November 14, 2003

Mr. Michael Deep
 Deep Associates
 1 Post Office Square
 North Adams, MA 01247

Re: Timeshare Model Relocations
 Existing First Floor Framing Review

Sheet 1 of 1

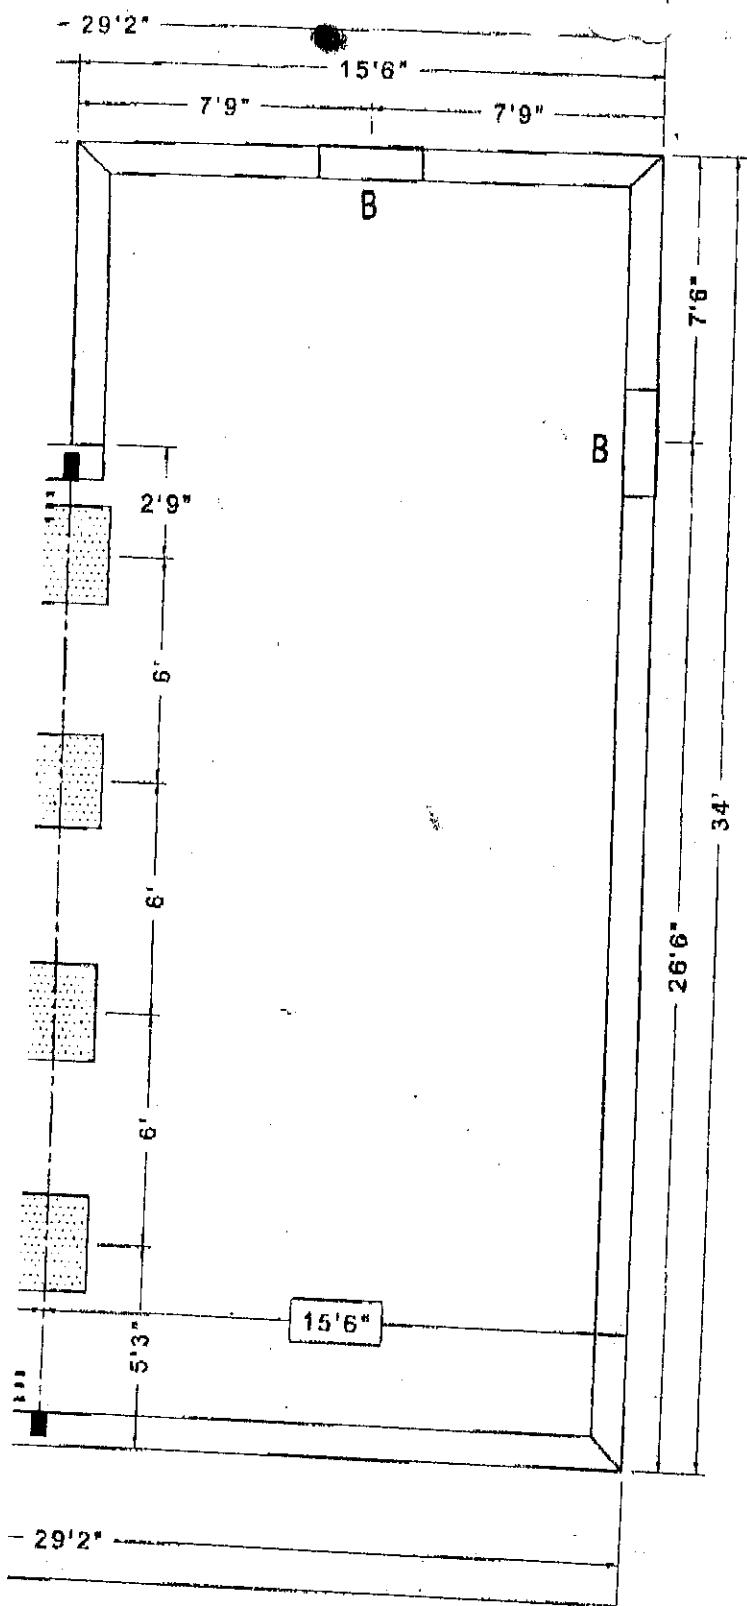
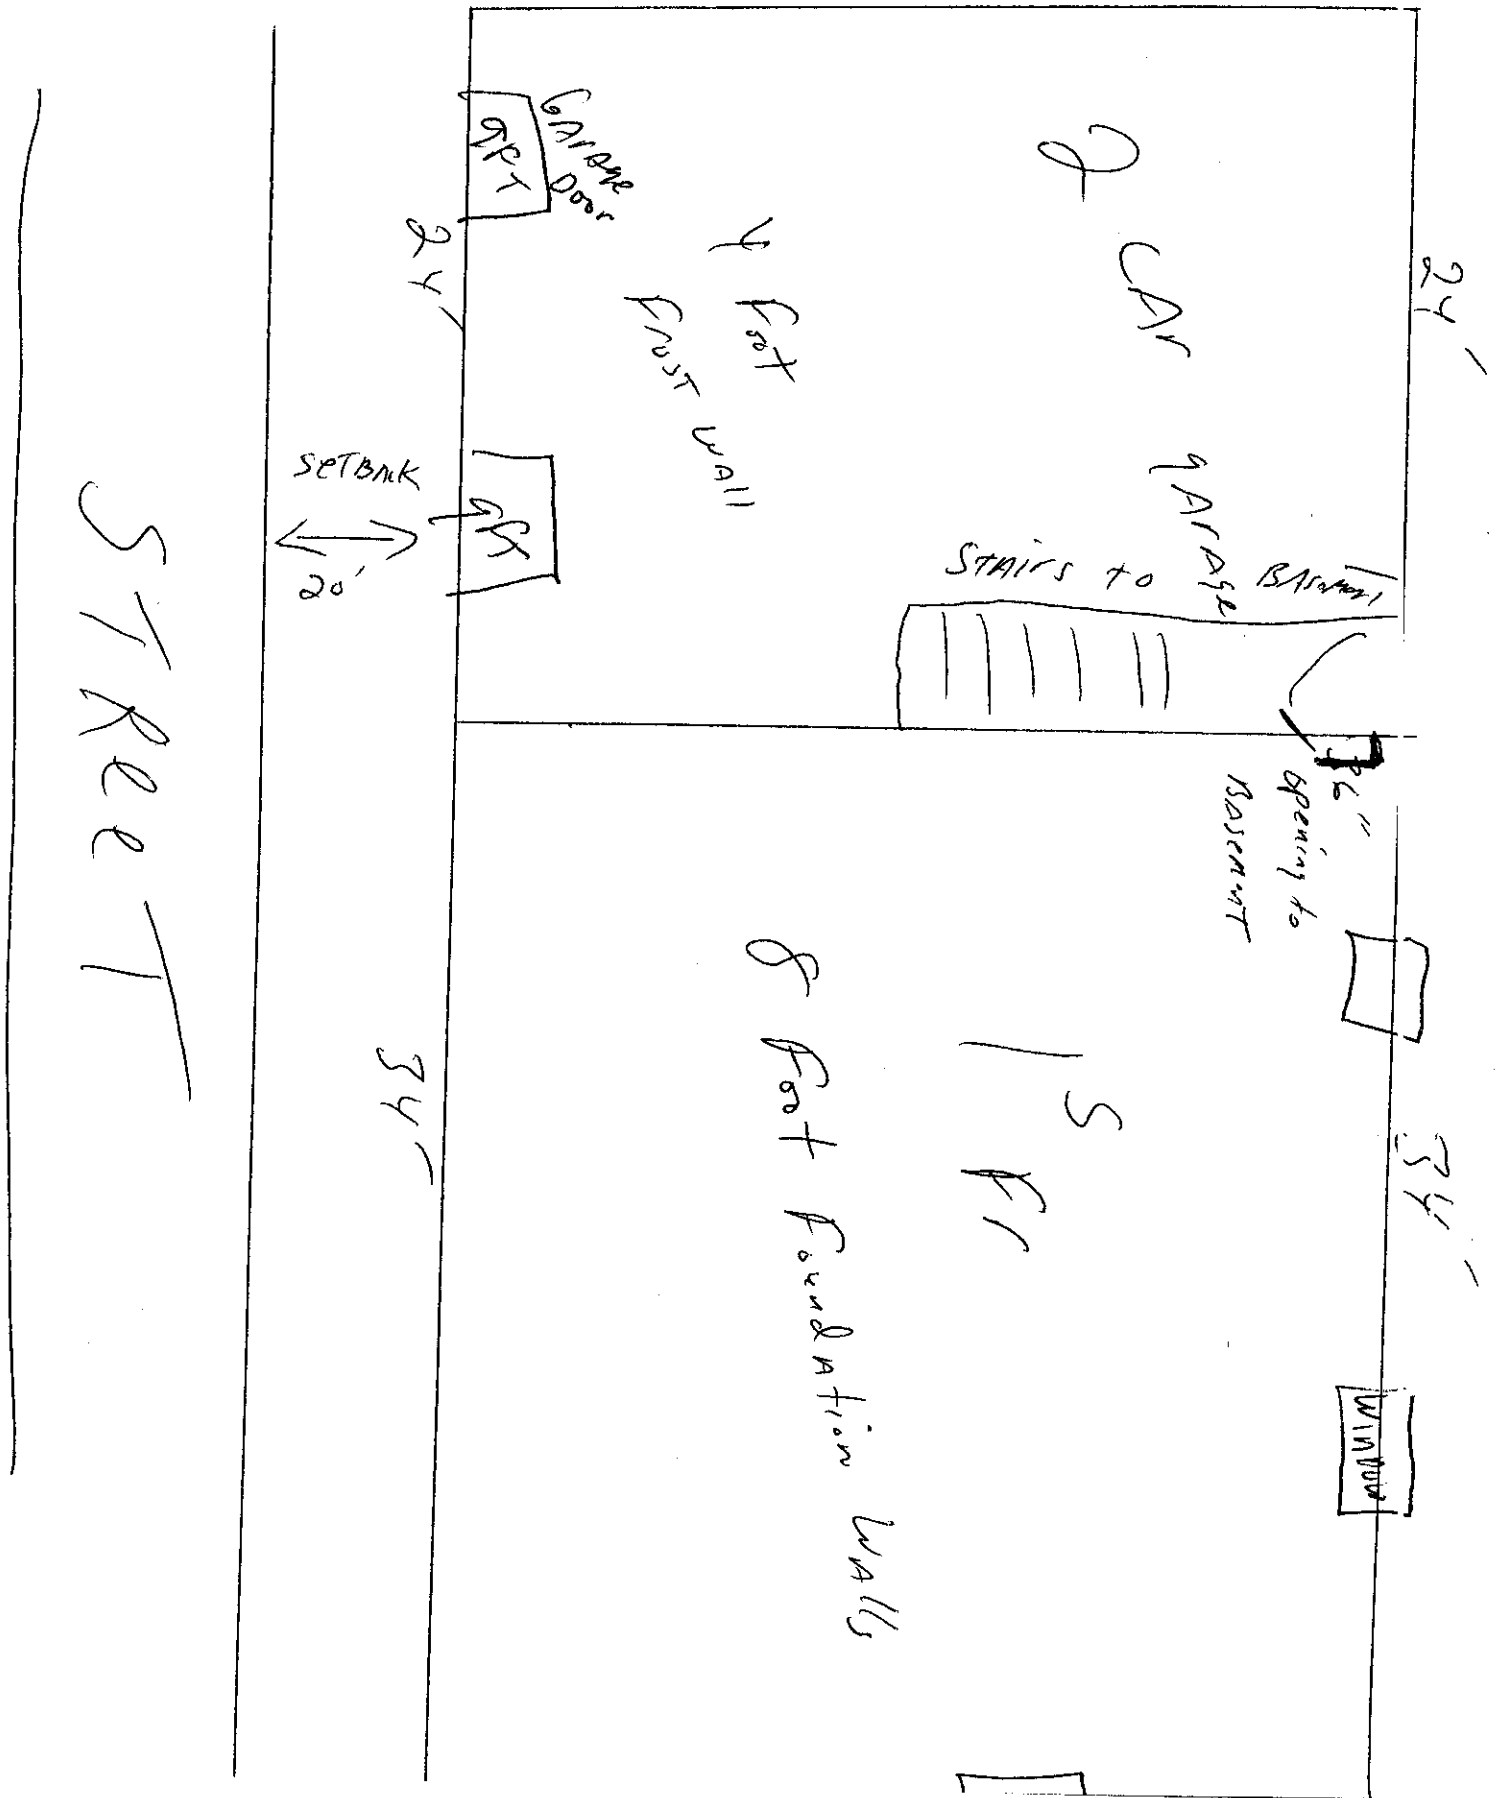
NOTE TO OWNER: THIS SHOP DRAWING SHALL BE REVIEWED AND RETURNED TO SWHY SIGNED AS "APPROVED" PRIOR TO FABRICATION. OWNER OR OWNER REPRESENTATIVE SHALL VERIFY THAT LAYOUT DIMENSIONS, ROUGH OPENINGS, TOP OF WALL ELEVATIONS, LEDGE ELEVATIONS, LOAD CAPACITY OF WALL AND POINT SUPPORTS MEET PROJECT REQUIREMENTS. OWNER OR OWNER REPRESENTATIVE SHALL VERIFY SOIL PRIOR TO INSTALLATION OF THE SUPERIOR WALL SYSTEM.

NOTICE: Builder is responsible for all site preparations including a minimum of 8" clean 1/2" diameter crushed stone. Sub footing to be 30" wide, centered under wall. Base of sub footing is to be below frostline and drained to daylight. Follow site prep. booklet by S.W.A. Builder to provide minimum soil bearing = 1 TSF.

X _____
Approved _____ Date _____

X _____
Approved as Noted _____ Date _____
